ARLINGTON VILLAGE BEAUTIFICATION AND MAGNOLIA IRRIGATION STREET IMPROVEMENT PLANS MAGNOLIA AVENUE

CITY OF RIVERSIDE, CALIFORNIA

ARLINGTON VILLAGE BEAUTIFICATION & MAGNOLIA IRRIGATION
STREET IMPROVEMENT PLANS
TITLE SHEET
COMMUNITY DEVELOPMENT
BLOCK GRANT (CDBG) PROJECT
Harrison Ave. to Castleman St.

R-3780
C-1
SHEET 1 OF 16
JOB NO. 03-3623

R-3780
SHEET L-10 OF 16
JOB NO. 03-3623

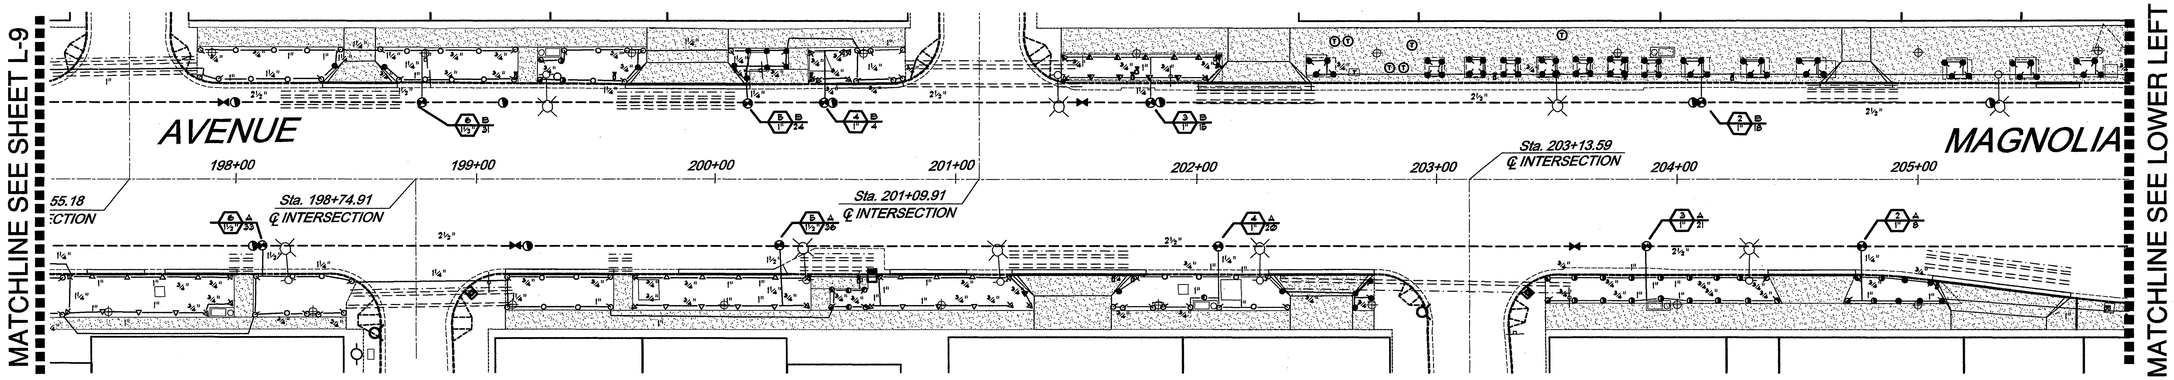
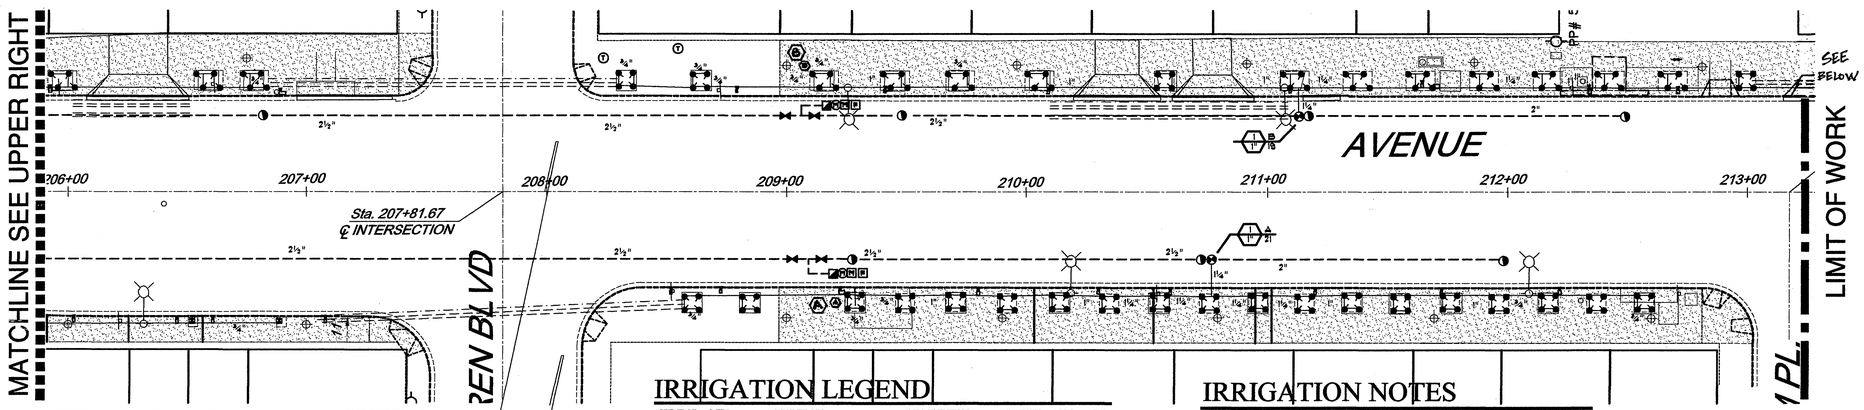
POINT OF CONNECTION 'B'
11/2" (DOMESTIC) WATER METER - COORDINATE LOCATION IN FIELD.
2" ~~11/2"~~ FEBCO 825YA REDUCED PRESSURE TYPE BACKFLOW DEVICE.
CONTRACTOR TO INSTALL A 2" MASTER VALVE / PRESSURE REGULATOR AND MASTER VALVE RELAY TO CONTROLLER.
COORDINATE THESE LOCATIONS WITH CITY INSPECTOR.

- (M) 2" BRASS MASTER VALVE SUPERIOR 950-DWPRS W/ PRESSURE REG. & SELF FLUSHING OR EQUAL.
- 2" ~~EXISTING 4"~~ REDUCED PRESSURE TYPE BACKFLOW DEVICE. ~~VERIFY LOCATION~~ TO BE LOCATED IN FIELD.

- [M] 1½" ~~2" (DOMESTIC) EXISTING~~ WATER METER - ~~VERIFY ON SITE FOR EXACT LOCATION.~~ TO BE LOCATED IN FIELD.
- 2" SIZE AND SMALLER SHALL BE NIBCO/APOLLO 70-008-01 BRASS BALL VALVE FULL PORT OR EQUAL. 2½" SIZE AND LARGER SHALL BE NIBCO T-136 OR MILWAUKE 1141 GATE VALVE OR EQUAL.

MARK	REVISIONS	APPR.	DATE
	REVISE IRRIGATION PER NEW HARDSCAPE LAYOUT		10/15/04
1	REVISIONS PER R.V. CITY STAFF	DH	10/20/04

SHEET L-11 OF 16

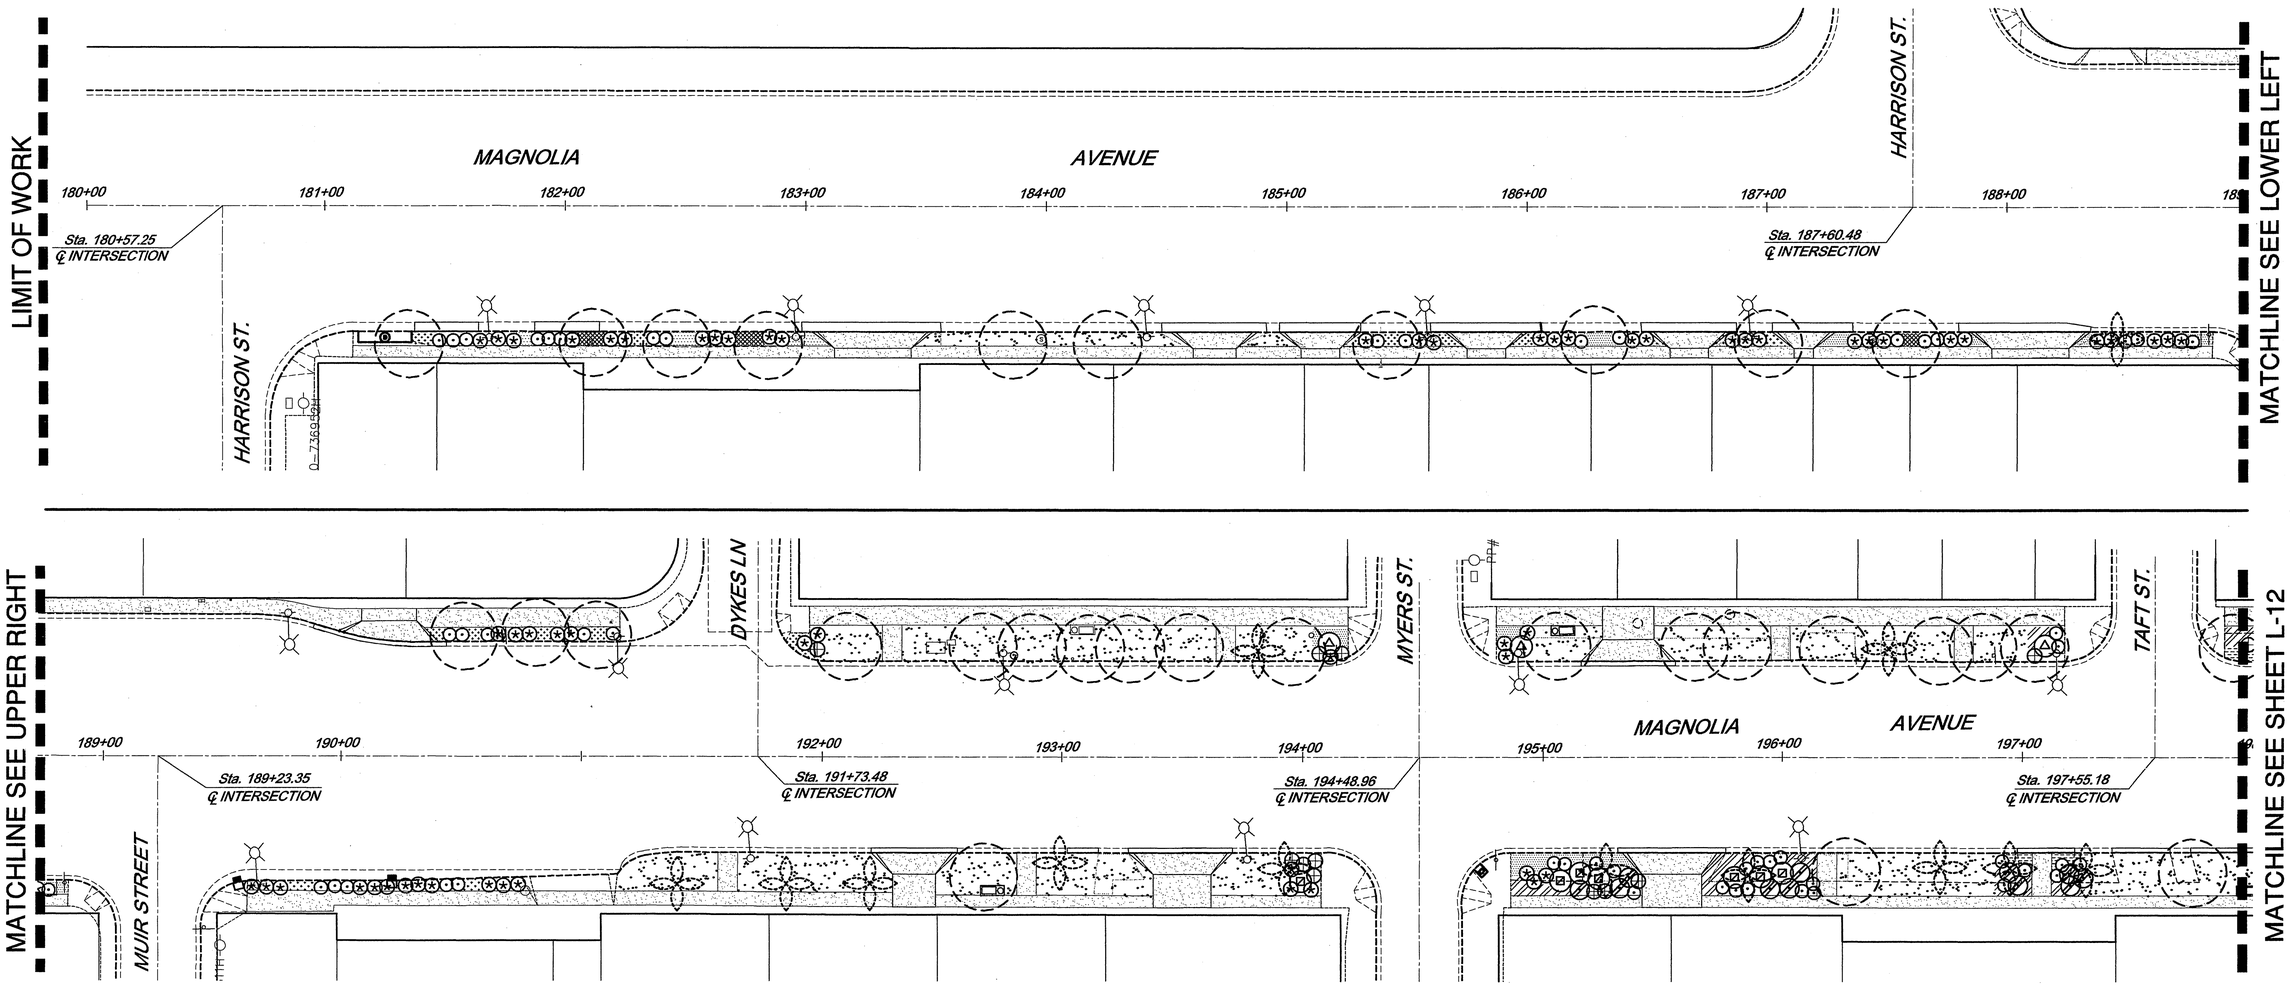
⚠ IPE ~~CHRYSOTRICHA~~ (~~GOLDEN~~ PINK TRUMPET TREE)
PROPOSED TABEBUIA REMOVE EXISTING TREE WHERE NECESSARY. 24" Box

MARK	REVISIONS	APPR.	DATE
⚠	REVISE PLANTING PER NEW HARDSCAPE LAYOUT	BH	10/15/04
⚠	REVISE TREE LEGEND	BH	10/21/04

R-3780
SHEET L-12 OF 16
JOB NO. 03-3623

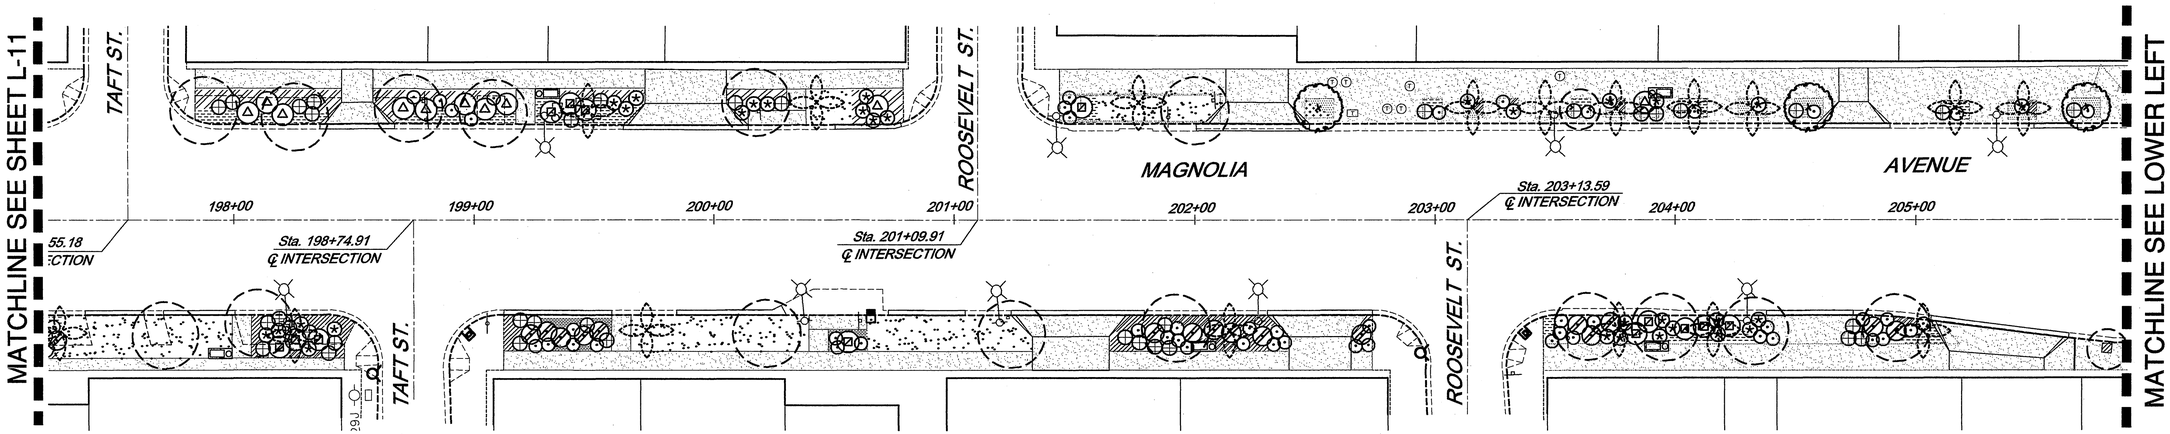
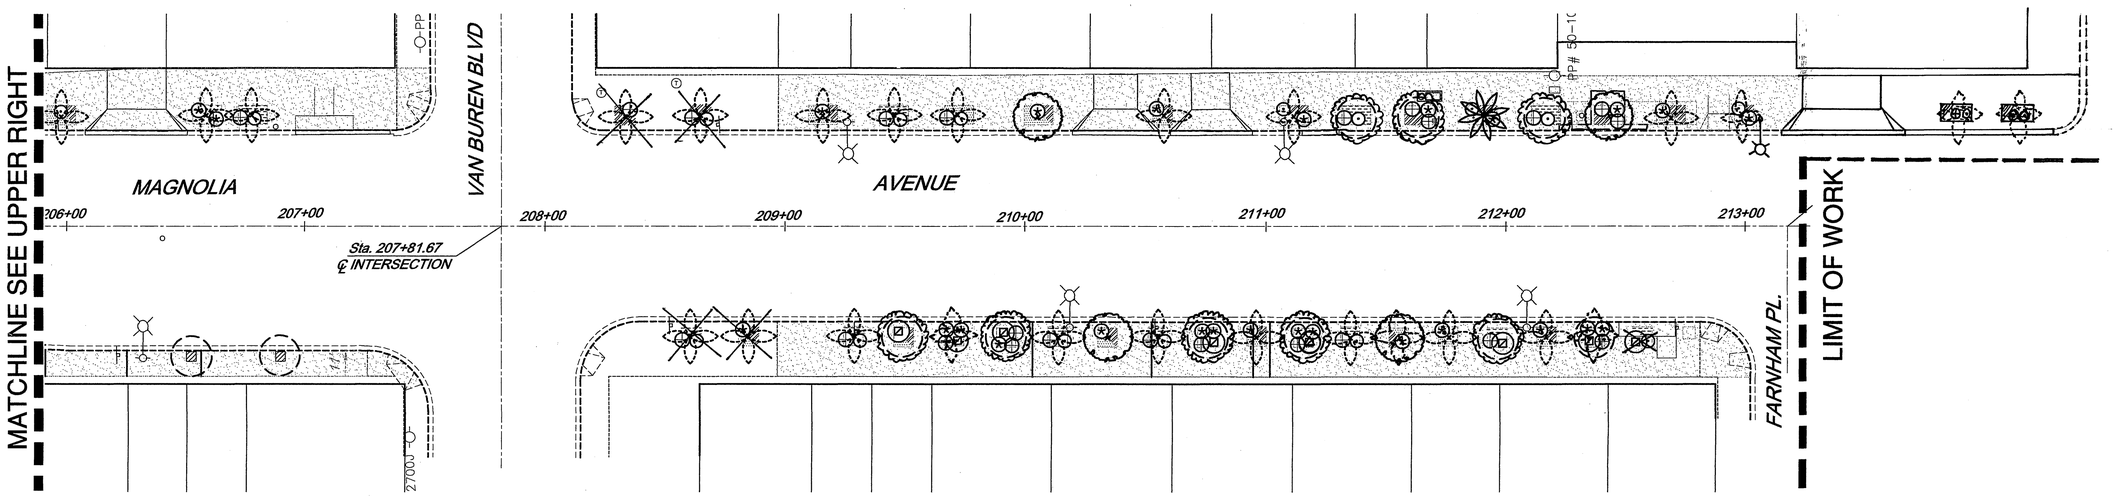
PROPOSED TABEBUIA ~~CHRYSOTRICHA~~ (~~GOLDEN~~ PINK TRUMPET TREE)
REMOVE EXISTING TREE WHERE NECESSARY. 24" Box

MARK	REVISIONS	APPR.	DATE
1	REVISE PLANTING PER NEW HARDSCAPE LAYOUT	PH	10/15/04
2	REVISED PER R.W. CITY STAFF.	PH	10/20/04
